**APPENDIX B**  
**COMMENT LETTERS**

**SUBJECT:** Review of Draft Environmental Impact Statement  
dated June 2008 and information presented at the  
December 4, 2008 Public Hearing for Jewish Congregation  
of Brookville, Village of Muttontown, Nassau County, N.Y.

Re: Technical Comments on  
Draft Environmental Impact Statement, June 2008  
Jewish Congregation of Brookville  
Incorporated Village of Muttontown

Your March 4, 2009 Submission  
Jewish Congregation of Brookville  
NY 106, Muttontown  
NCTM No. 15-A-2429, 2430  
Our Case No. 06-058P

FIGURE D103.1  
DEAD-END FIRE APPARATUS ACCESS ROAD TURNAROUND

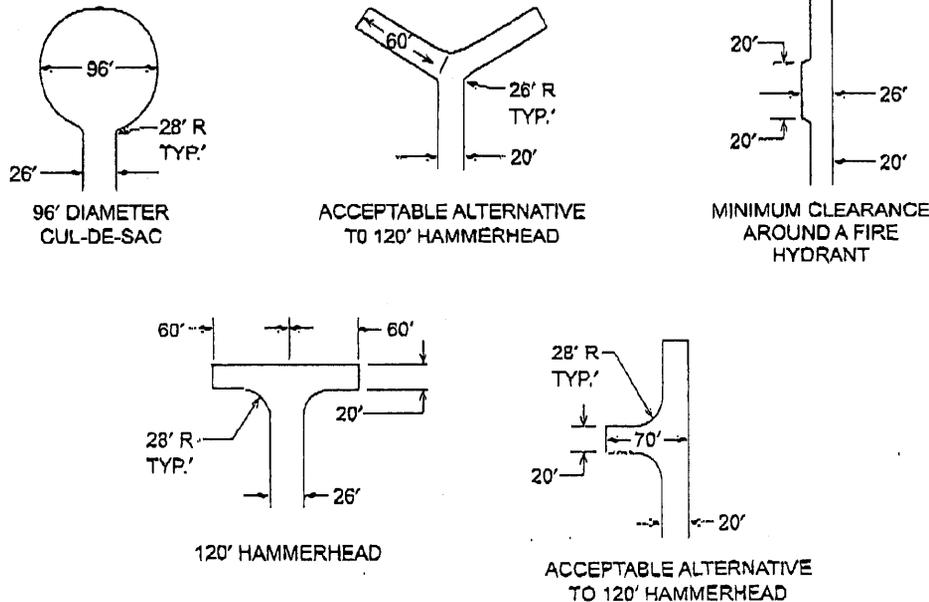
3. Provide as many on site fire hydrants as are necessary, to conform to the requirements of Section 508.5.1 of the Fire Code of New York State. The distance from a hydrant on a fire apparatus access road, as measured by an approved route around the exterior of the building, is 600 feet. A fire apparatus access road has a minimum clearance around a fire hydrant of 26 feet, as per Figure D103.1 of Appendix D (See copy of Sec.508.5.1 and Appendix D)
